# Access Compliance Report

## Public Rights-of-Way

### (Curb Ramps)

Intersection ID: 46765	Main Street: FRIENDSHIP_VILLAGE_PL	Cross Street: MISSIONARY_AV	Location: SE
ADA ID: 7956962A1976	Ramp Type: PerpDiag	Initial Pass/Fail: Fail	Overall Compliance: No
Severity Score: 22.5			
Codes/Mitigation Info/Possible Solution		Field Measurements/Component Compliance

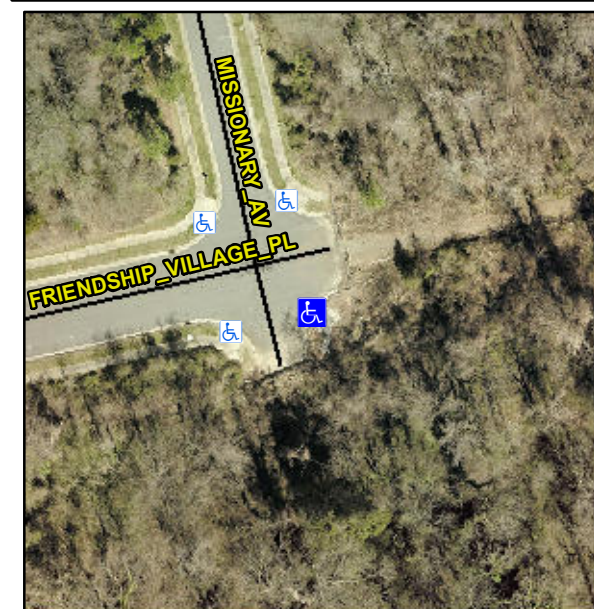
**Not Found, R304.5.1, R304.2.2**

Compliance	Description	Data	Compliance	Description	Data
N/A	Ramp Length (in)	73.5	No	Ramp Slope (%)	10.7
No	Ramp Width (in)	37.5	Yes	Ramp XSlope (%)	3.2
N/A	Flare Type LT	N/A	N/A	Flare Type RT	N/A
N/A	Flare Slope LT (%)	N/A	N/A	Flare Slope RT (%)	N/A
N/A	Flare Traversable LT?	N/A	N/A	Flare Traversable RT?	N/A
N/A	Landing Length (in)	N/A	N/A	DWS Provided?	N/A
N/A	Landing Width (in)	N/A	N/A	DWS Contrast?	N/A
N/A	Landing Slope (%)	N/A	N/A	DWS Length (in)	N/A
N/A	Landing X Slope (%)	N/A	N/A	DWS Full Width?	N/A
N/A	Landing Curb? (Y/N)	N/A	N/A	DWS Offset (in)	N/A
N/A	Shared Landing?	N/A			
N/A	Gutter Ponding?	N/A	N/A	Gutter Slope (%)	N/A
N/A	Gutter Lip Ht (in)	N/A	N/A	Gutter X Slope (%)	N/A
N/A	Painted X Walk1?	No	N/A	Painted X Walk2?	No
	X Walk 1 Direction	To N		X Walk 2 Direction	To W
N/A	X Walk 1 Width (in)	N/A	N/A	X Walk 2 Width (in)	N/A
	X Walk 1 Slope (%)	2.7		X Walk 2 Slope (%)	3.7
	X Walk 1 X Slope (%)	4.9		X Walk 2 X Slope (%)	0.9

**Remove & Replace Curb Ramp With Two New Directional Ramps or Equivalent.**
